**Intel[®] 82371AB PIIX4,
Intel[®] 82371EB PIIX4E,
Intel[®] 82371MB PIIX4M**

Specification Update

January 2002

Document Number: **297738-017**

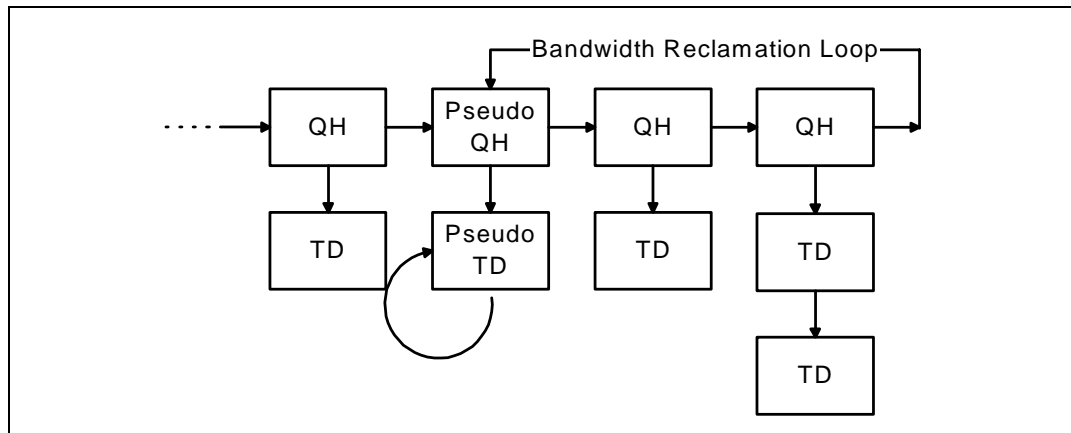
TD CONTROL AND STATUS (DWORD 1: 04-07h)

The Active status bit (bit 23) must be left unset at 0 indicating that the PIIX4/PIIX4E/PIIX4M should not execute this TD.

QUEUE HEAD LINK POINTER (DWORD 0: 00-03h)

The Queue Head Link Pointer (QHLP=bits [31:4]) must be set to point to the pseudo TD.

Status: This erratum will not be fixed in PIIX4/PIIX4E/PIIX4M. This erratum is planned to be incorporated into the next revision of the PIIX4 datasheet as a specification change. Intel is working with Microsoft to incorporate the workaround into their UHCI driver. Microsoft will make this workaround available in the Beta 1 release of Memphis. Microsoft will provide a fix to the OSR2.1 (Detroit) release. OEMs/IHV's should contact Microsoft for the fix distribution plans.
